World Forum for Harmonization of Vehicle Regulations**Working Party on Automated/Autonomous and Connected Vehicles****Seventeenth session**

Item 7(a) of the provisional agenda

Advanced Emergency Braking System:**UN Regulations Nos. 131 and 152****Proposal for a supplement to 01 series of amendments to UN Regulation No. 152 (Advanced Emergency Braking System for M₁ and N₁ vehicles)****Submitted by the expert from France***

Figure 5

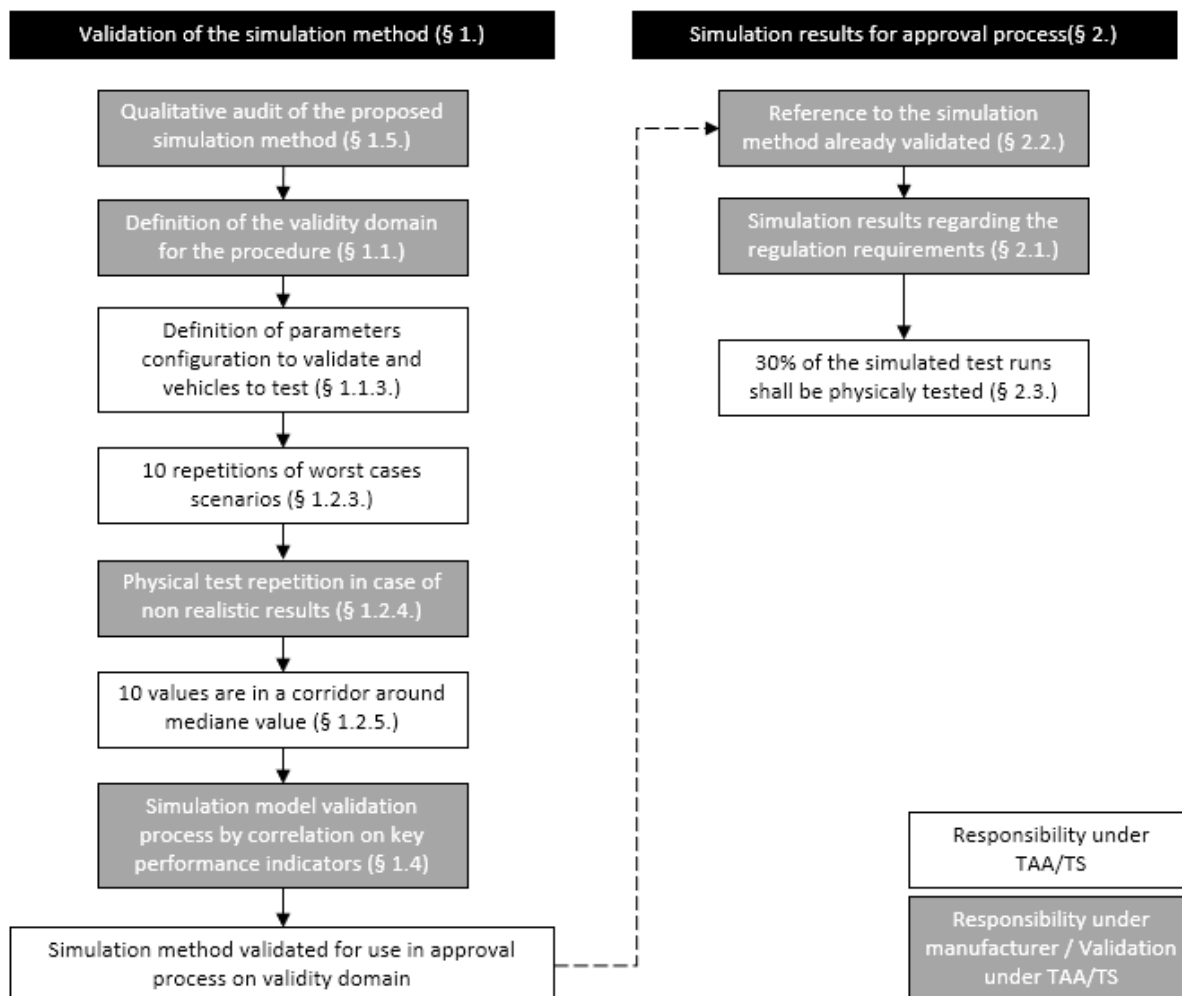
This global approach is summarized step by step in the scheme below figure 5 and further detailed in the following chapters.

Generic flow chart of the “Computer simulation of dynamic tests as an equivalent approval method”
